APPENDIX 32B

Reproductions of Comments on the Draft EIS

ER21/0248 August 3, 2021

Subject: Comments on Draft Environmental Impact Statement, Little Cottonwood Canyon Wasatch Boulevard to Alta, Salt Lake City, Utah

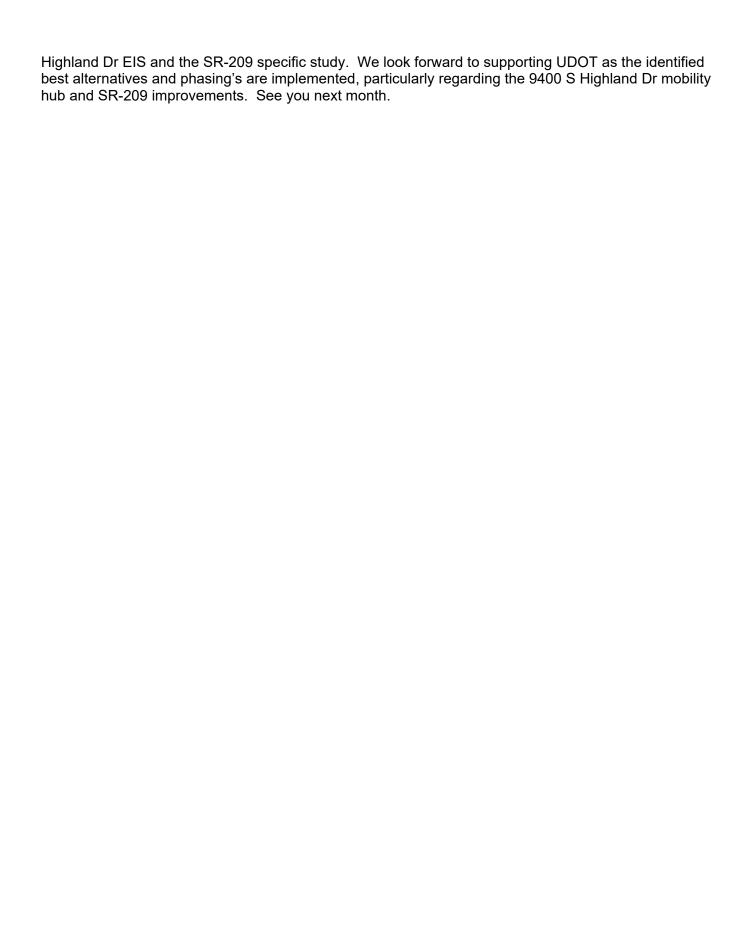
The placement of Table 7.4-7 is strange here. The document has only discussed the No Action and the Enhanced Bus alternatives thus far. The same could be said about Figure 7.4.1. A better place for these images would be at the end of the chapter. (32.7J)

The last paragraph states that LOS C was used to represent the worst-case noise conditions while traffic was un-congested. As UDOT's design goal is LOS D, using a LOS D in the noise study could be more justifiable. Accordingly, LOS D is also the worst-case LOS desired for the 30th highest hour. However, we did discuss this comment with you at our most recent monthly meeting. To the effect of what was explained in our meeting, I suggest adding clarification that using LOS C is more conservative because higher noise is experienced at this level. (32.11M)
